**TOWN OF NEWBURGH
PLANNING BOARD
TECHNICAL REVIEW COMMENTS**

PROJECT: PEAK SUMMIT SUBDIVISION
PROJECT NO.: 16-13
PROJECT LOCATION: SECTION 17, BLOCK 1, LOT 40.2
REVIEW DATE: 11 NOVEMBER 2016
MEETING DATE: 17 NOVEMBER 2016
PROJECT REPRESENTATIVE: ZEN DESIGN

PEAK SUMMIT ENTERPRISES, INC.
 3 LOT SUBDIVISION
 LOT LAYOUT
 FOSTERTOWN ROAD, SBL: 17-1-40.2
 TOWN OF NEWBURGH, ORANGE COUNTY, NY

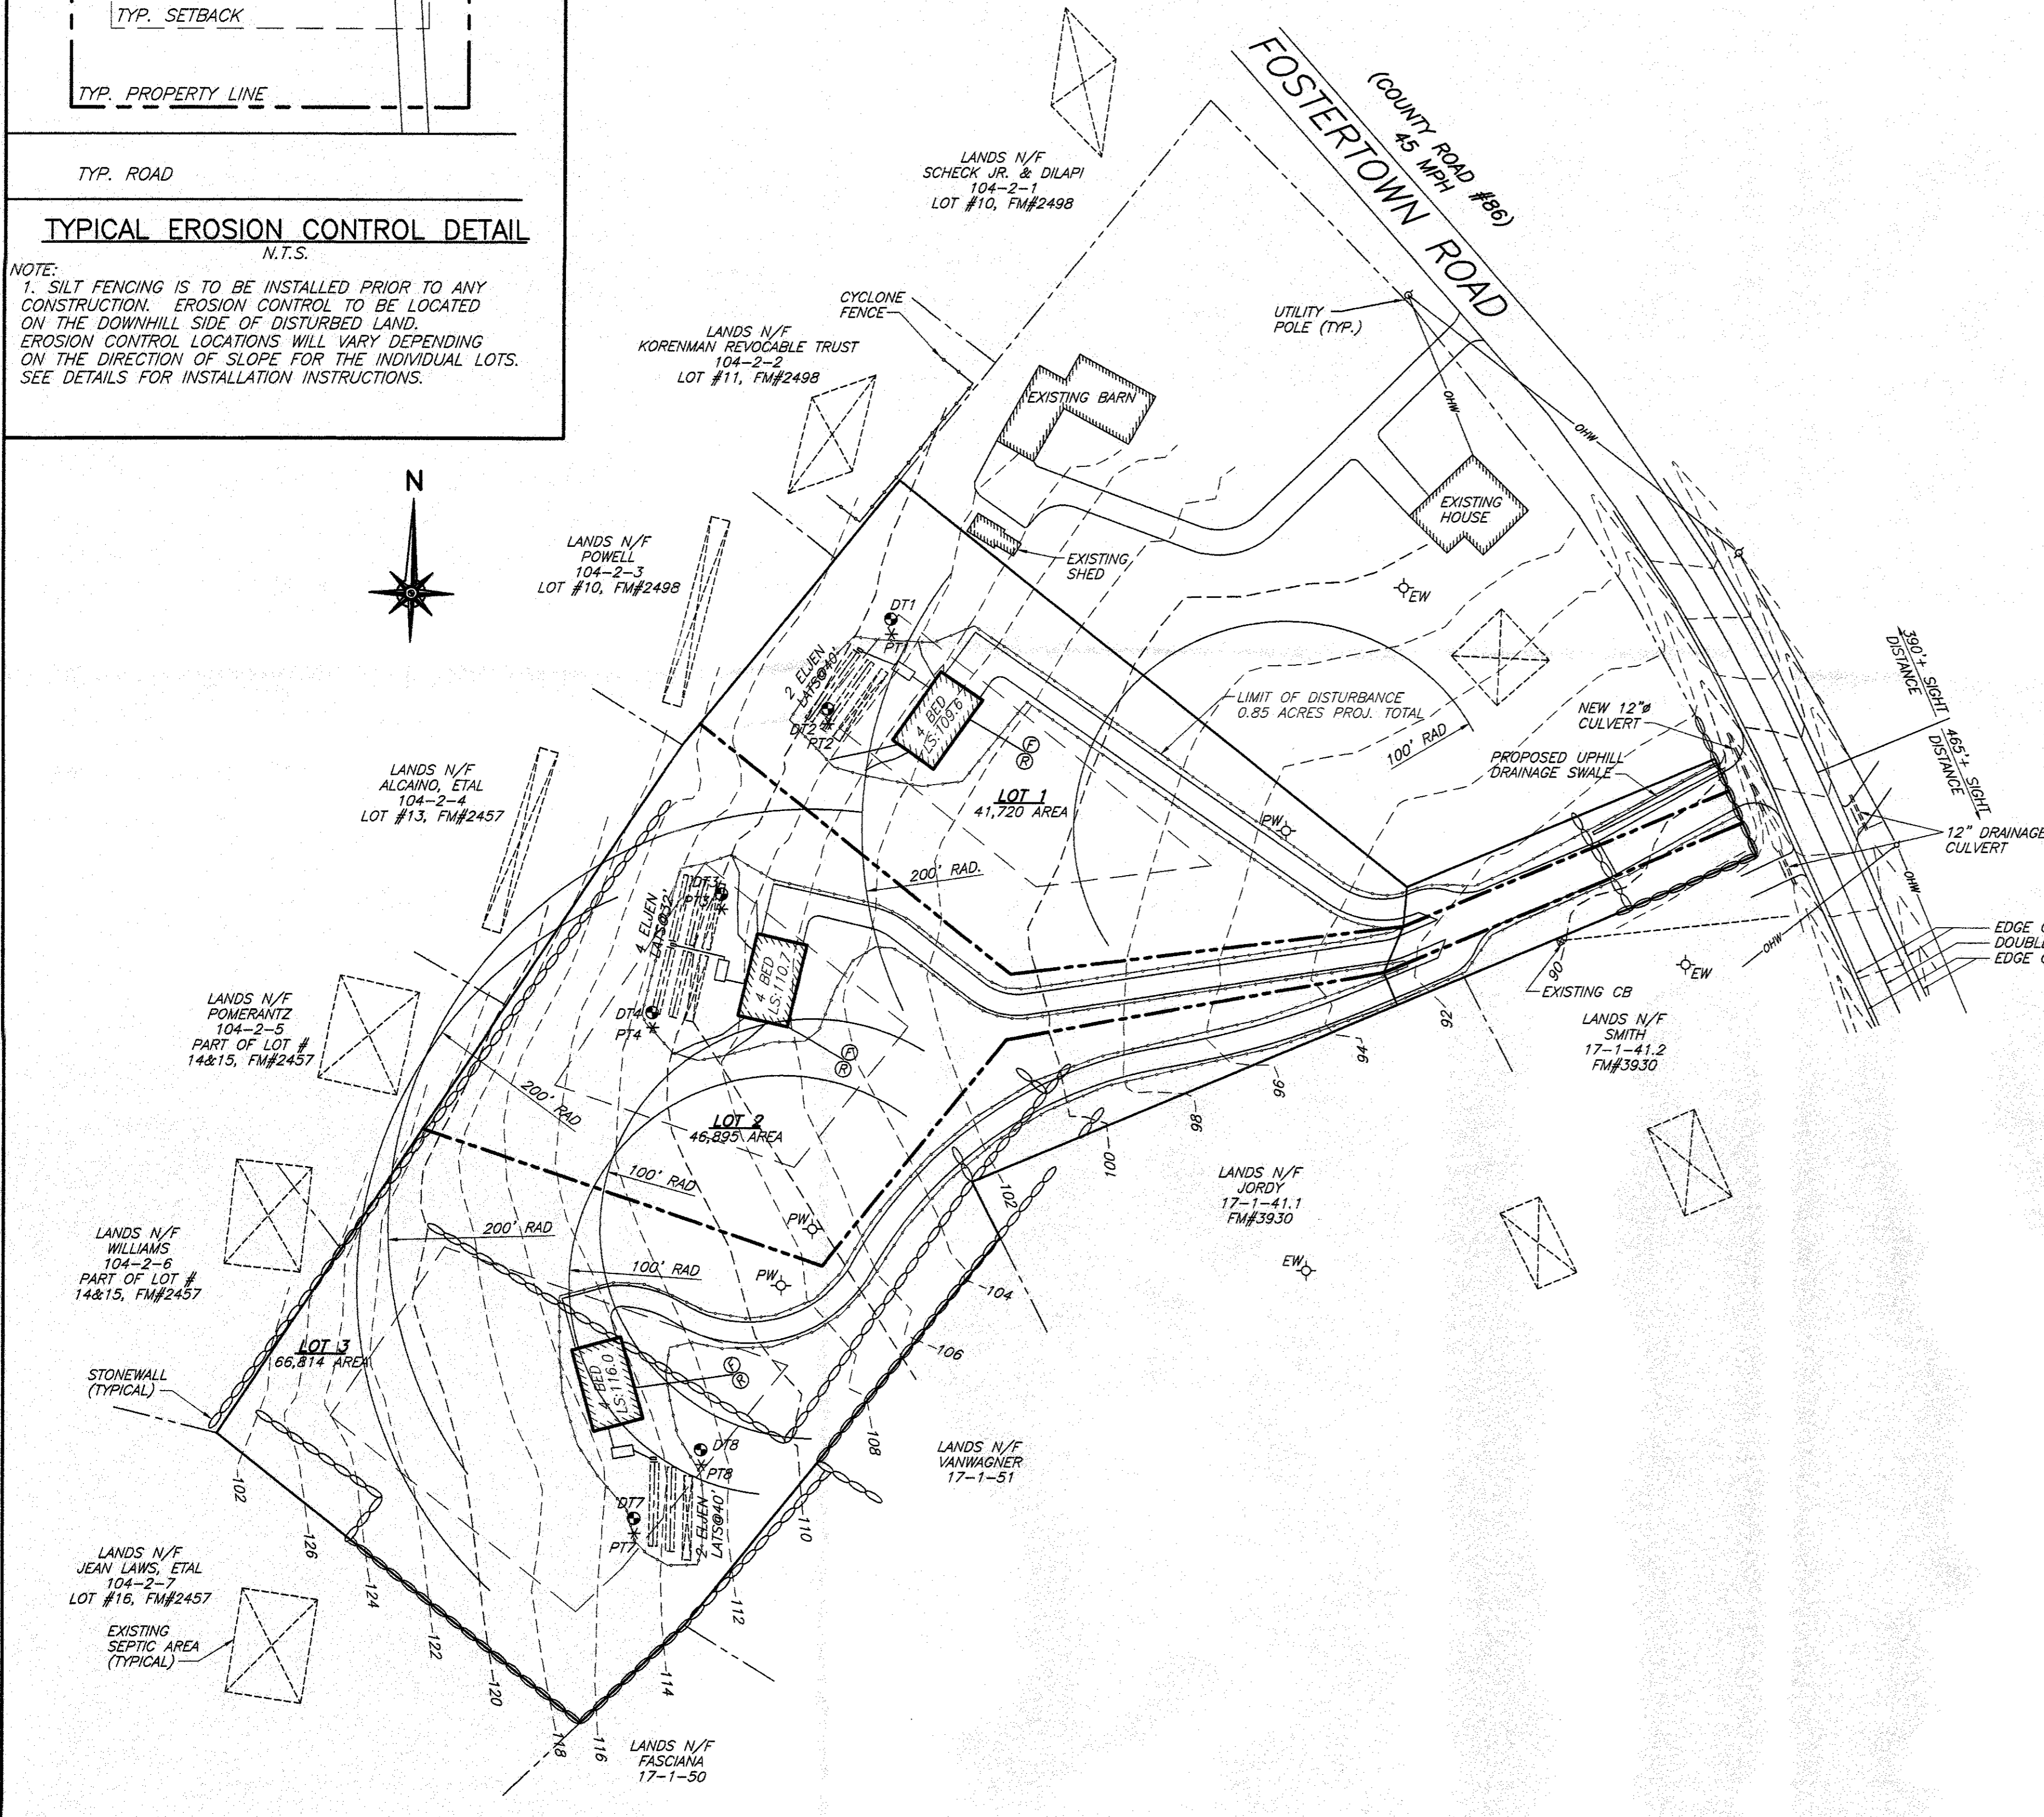
1. Status of the road name with the Town of Newburgh Town Board should be addressed.
2. County Planning circulation was sent on 6 September 2016. Status of Orange County review should be addressed.
3. The Applicants representative have revised the common driveway and location of the houses on the site to reduce the amount of disturbance on the site. Previously the amount of disturbance was approaching the 1 acre threshold for the need for a Stormwater SPDES permit. Re-location of the houses have reduced the potential impacts to below the permit threshold.
4. Any approvals should be conditioned on receipt of an Orange County Department of Public Works highway access permit.
5. Common driveway access and maintenance agreement approval from Mike Donnelly's office is required.
